Division of Water Rights

November 2, 2009

RE: SEAA No. 1290, Measuring flumes, Logan Island No. 1 and 6&7

Logan Island Ditch No. 6&7

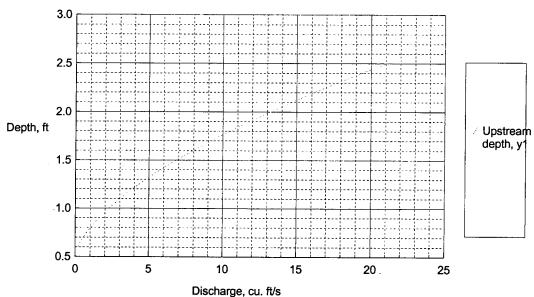
The 2-foot concrete ramp flume on Logan Island No. 6&7 ditch was inspected after the water was turned out at the end of the season. Based on our inspection, it appears the flume should function properly. However, without observing it in operation, we cannot fully verify its performance at this time. We plan to conduct another inspection when the flume is operational next irrigation season. My main concern is the uncertainty of how the upstream and downstream pipelines influence the normal operation of the flume. Enclosed is a rating table based on flume geometry and normal channel flow conditions. Slight changes can be made to this table, if needed, after observing the actual flume operation. Large deviations from this table or large fluctuations in the water level could indicate problems with the flume/channel configuration and require future modification.
